Client: 84 Lumber – Fayetteville, NC
Project: Caviness Land – CL2302 CP GL
Address: 114 Silk Oak Drive, Bunnlevel, NC

I have reviewed attached Design Reports created by U.S. Lumber for the client and project listed above. These member calculations for Louisiana-Pacific joists and/or beams were prepared using the isDesign™ software package based on design information and conditions provided by the client.

Attachments: Member Design Reports dated 09/30/2020 (5 pages total – including this cover letter).

CL2302 CP GL_2nd Flr_HD2-A LP-LSL 1.55E 3.500" X 11.875" - PASSED Level: 2nd Flr

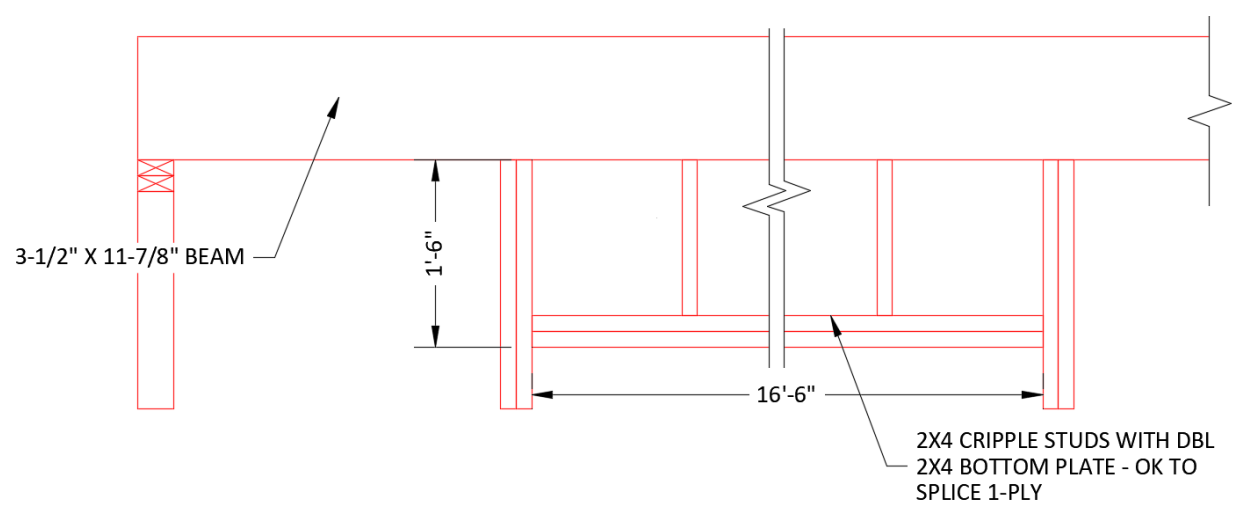
Beam OK installed high in wall (under double top plate) and framing below to garage door opening per detail on page 2

CL2302 CP GL_2nd Flr_HD1-A LP-LSL 1.55E 3.500" X 9.250" - PASSED

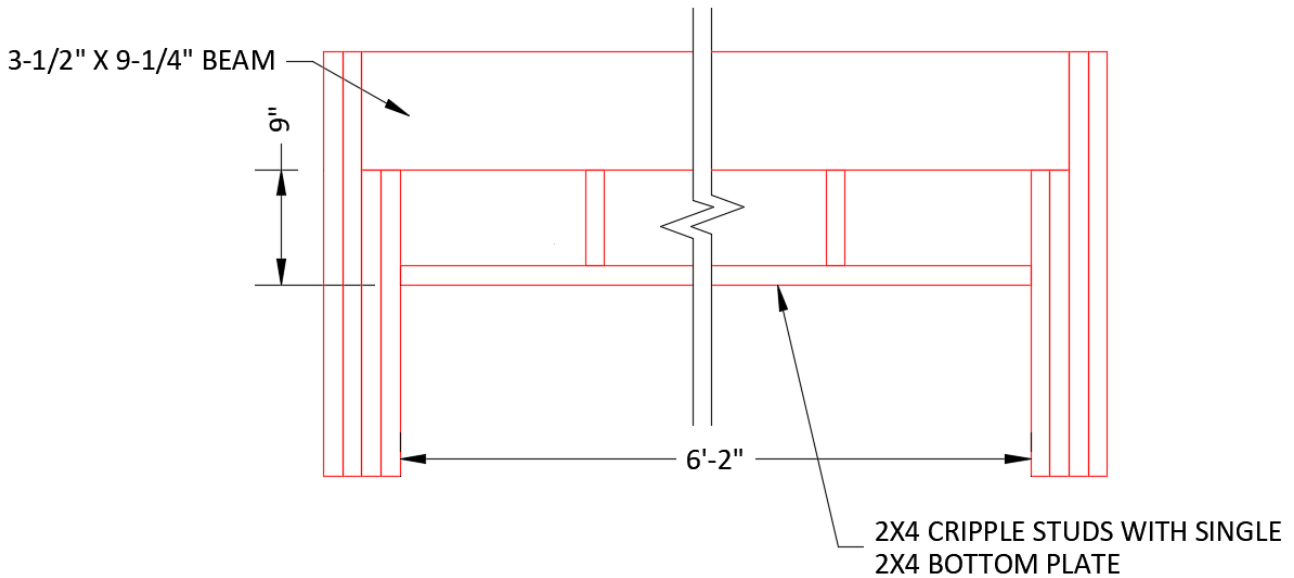
Beam OK installed high in wall (under double top plate) and framing below to door opening per detail on page 2
